Joan McDonald, Commissioner NYS Department of Transportation 50 Wolf Road Albany, New York 12232 December 18, 2013

re: Protecting Safety and Beauty at Western Gateway Bridge

## Attachment 1

Above: only a curb now for protection

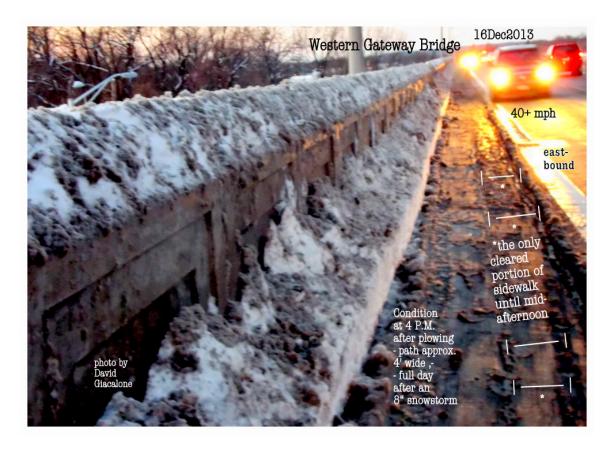
PEDESTRIAN HAZARD!

Without guardrails, the very people we hope will take advantage of the many amenities available on the Scotia side of the bridge (movies, a Library, Collins Park, tennis, restaurants, hot dogs and ice cream), and the attractions on the Schenectady side (like the Stockade and SCCC activities) will be the most at risk. Small children, students and bike path users will be crossing almost half a mile alongside rapid traffic and danger.
